# A d d e n d u m

Iowa Department of Transportation  
Office of Contracts

<b>B.O.</b>	<b>Proposal ID</b>	<b>Proposal Work Type</b>	<b>County</b>	<b>Project Number</b>	<b>Addendum</b>
302	58-0613-057	GRADING	LOUISA	NHSX-061-3(57)--3H-58 NHSN-061-3(77)--2R-58	21OCT302.A03

**SUBGRADE TREATMENT OPTIONS**

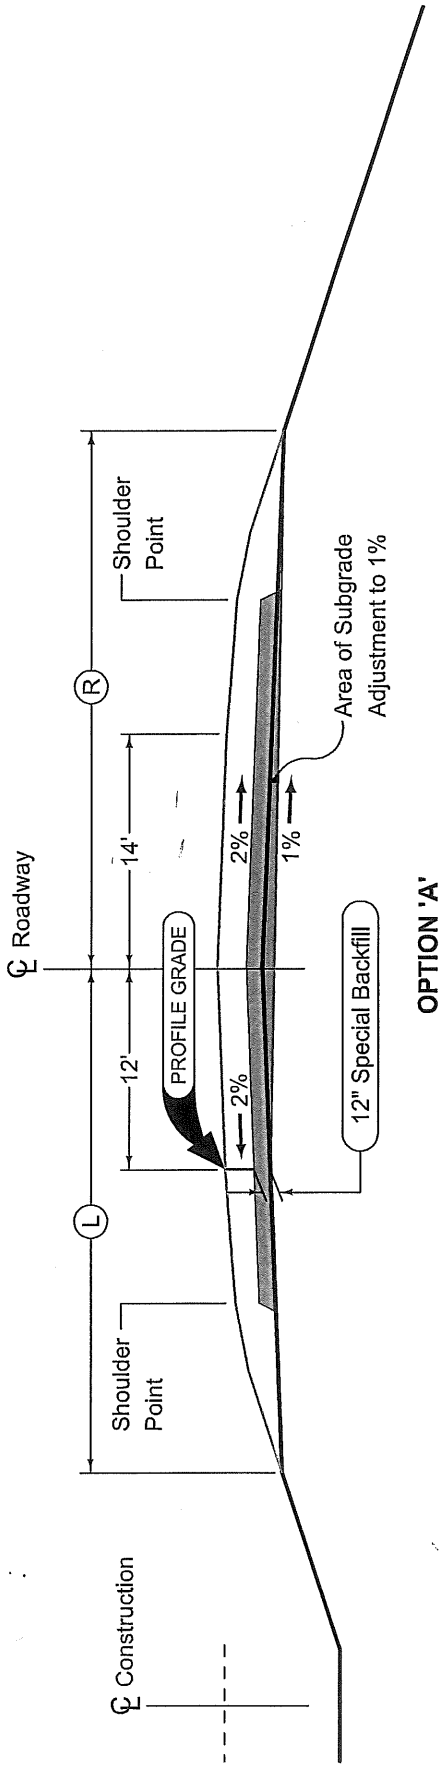
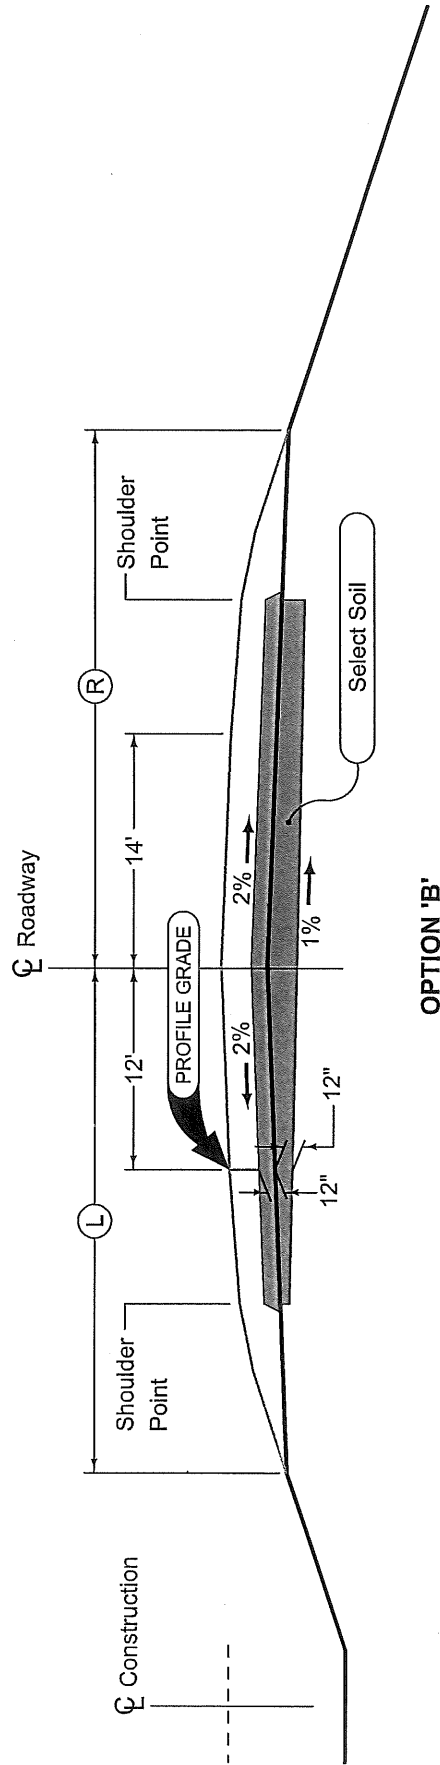
SHEET B.1:

Add the attached SUBGRADE TREATMENT OPTIONS.
